**The Scottish Government  
Energy Consents Unit**

**Scoping Opinion on behalf of Scottish Ministers under the  
Electricity Works (Environmental Impact Assessment) (Scotland)  
Regulations 2017**

**Blair Hill Wind Farm  
Renewable Energy Systems (RES) Ltd**

**13 November 2023**

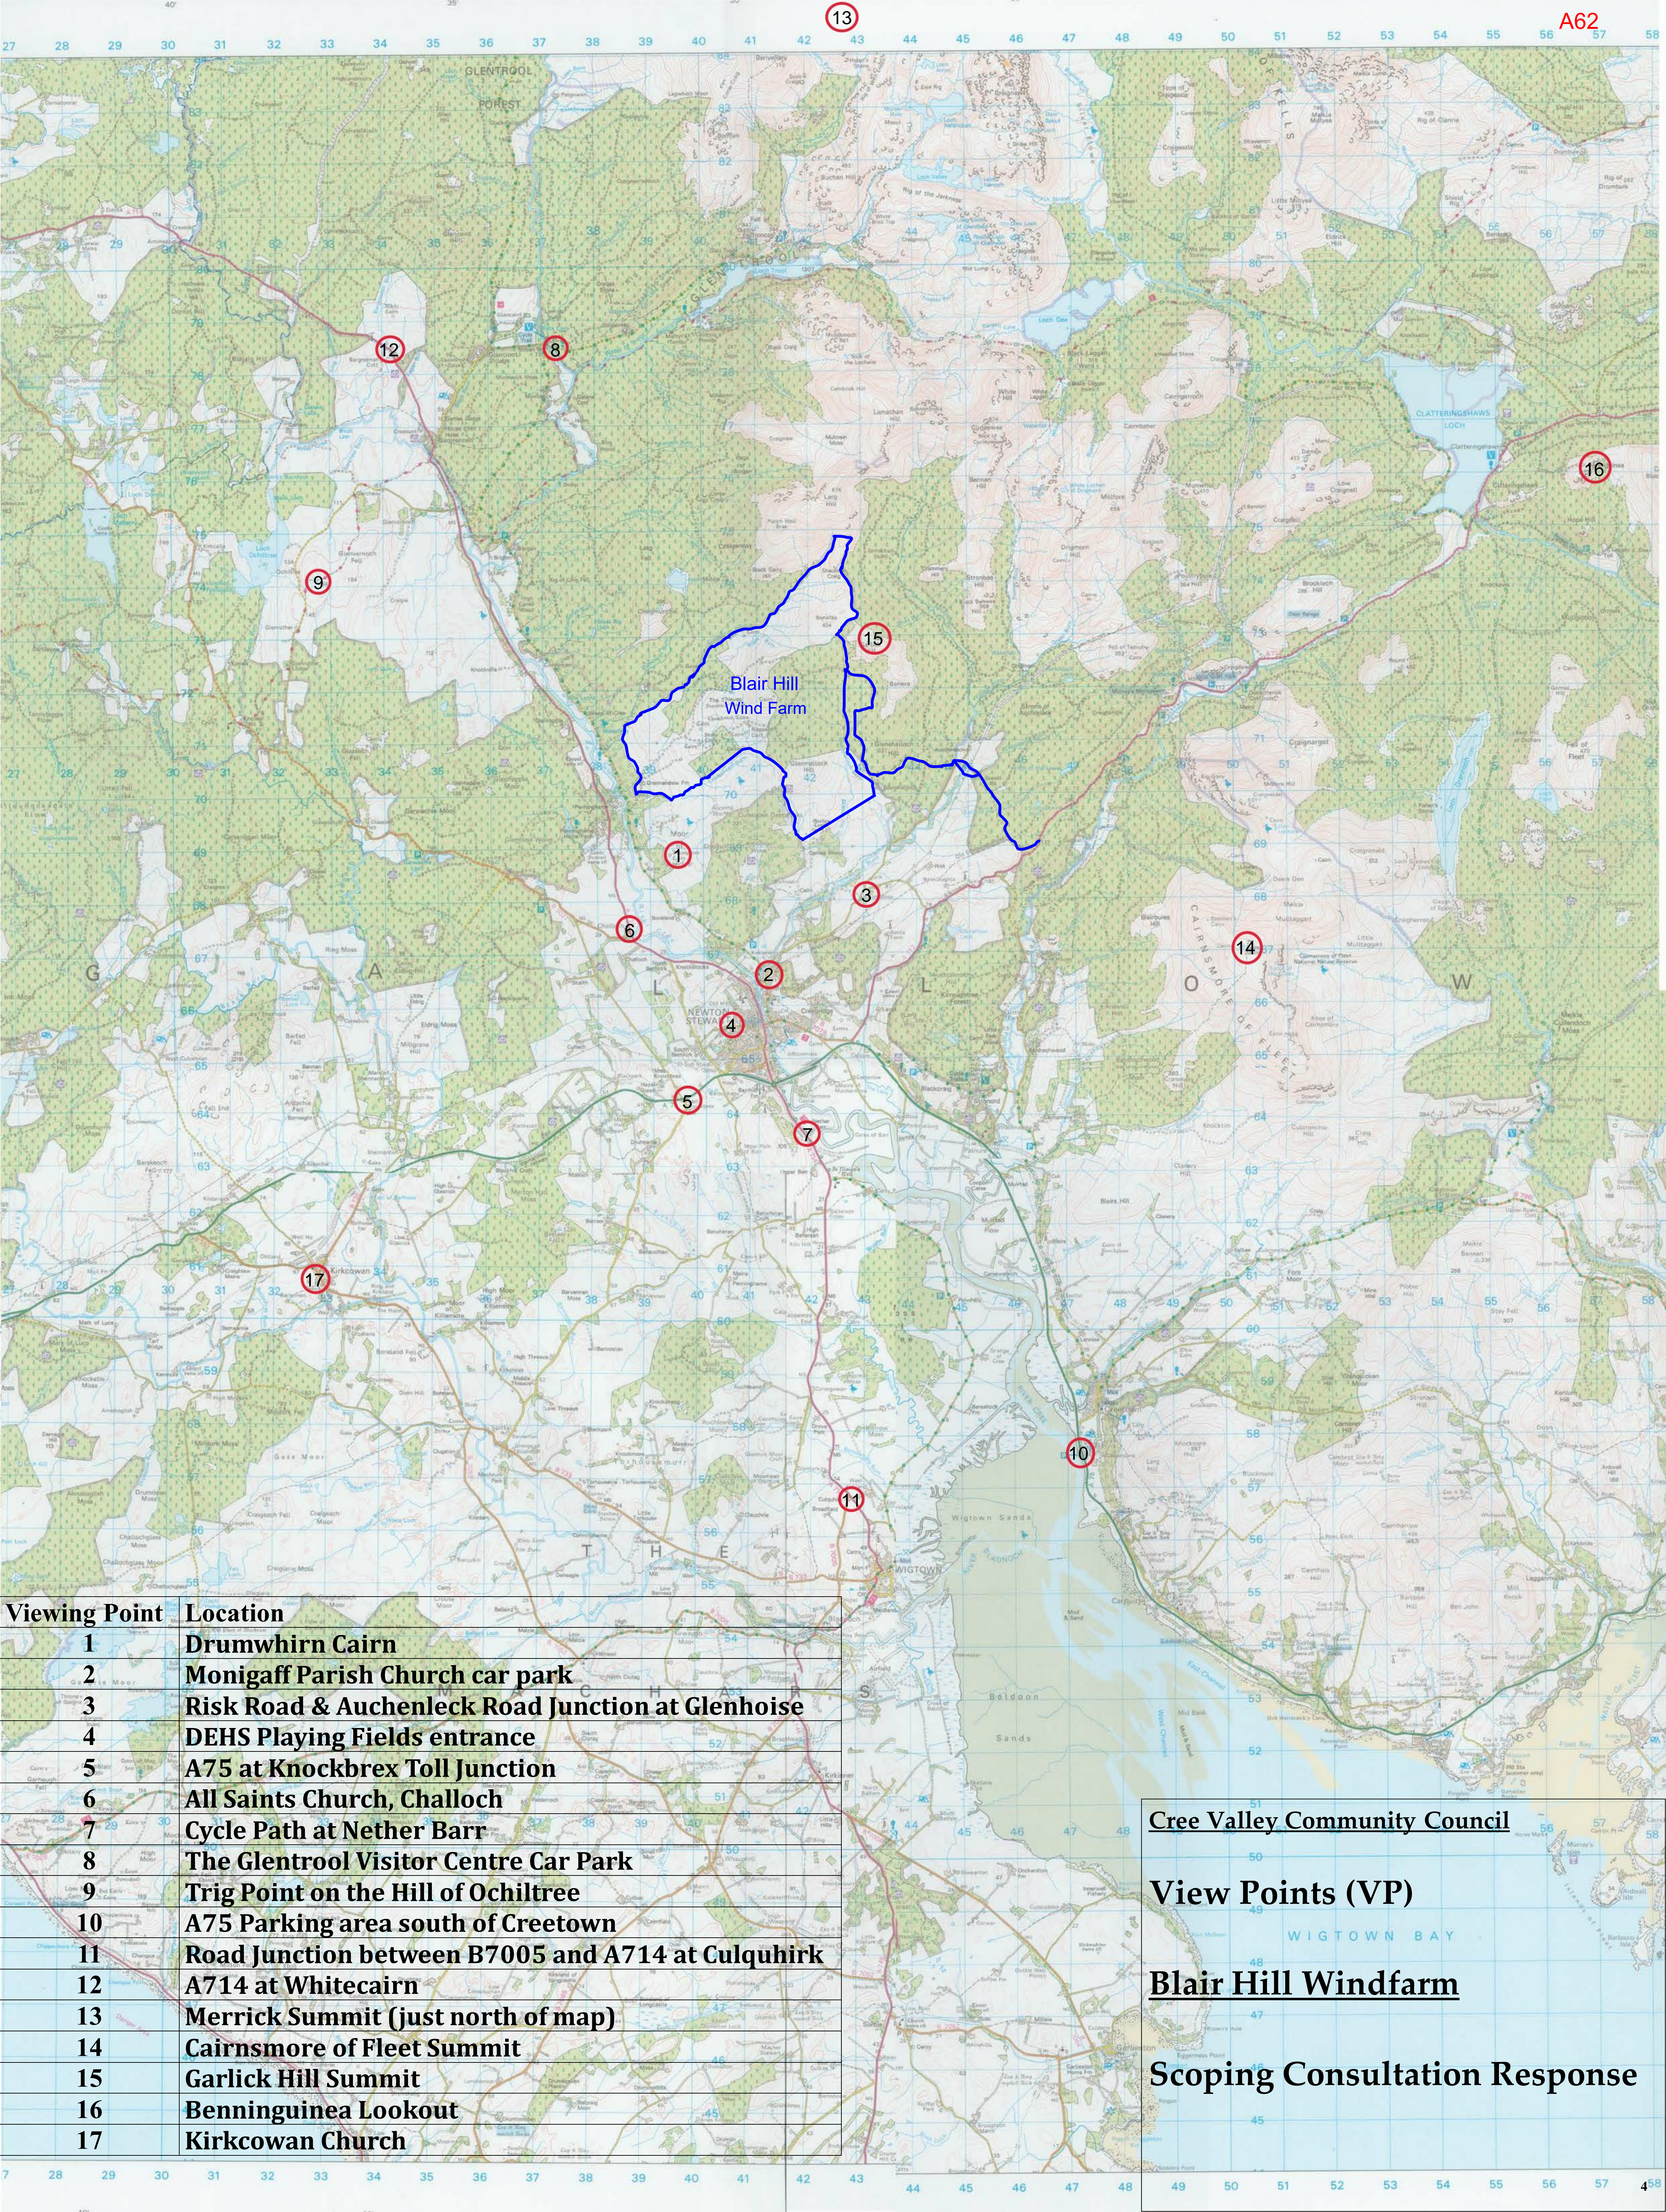
With regard to the list of Viewpoints provided by RES. The official guidance contained in both "Visual Representations of Windfarms, SNH/Nature Scot 2017", and "Guidelines for Landscape and Visual Impact Assessment, LEMA" indicates that the list of viewpoints selected by RES for LVIA is inadequate and requires to be revised. We suggest that the following list of viewpoints is much more in keeping with the official guidance and is appropriate if the significant visual impacts of the Blair Hill Wind Farm are to be properly understood.

VP9- The trig point at the high point of the Hill of Ochiltree. The Southern Upland Way passes through this point. This location has historical importance being the site of a main fort on the ruined Deil's Dyke, a rampart constructed by the Novantae to demarcate their territory in the period after Roman influence ended in Galloway.

VP18- Southern Upland Way at Artfield Fell.

VP20- Southern Upland Way above Stranraer.

VP21 - A714 North of Whithorn.
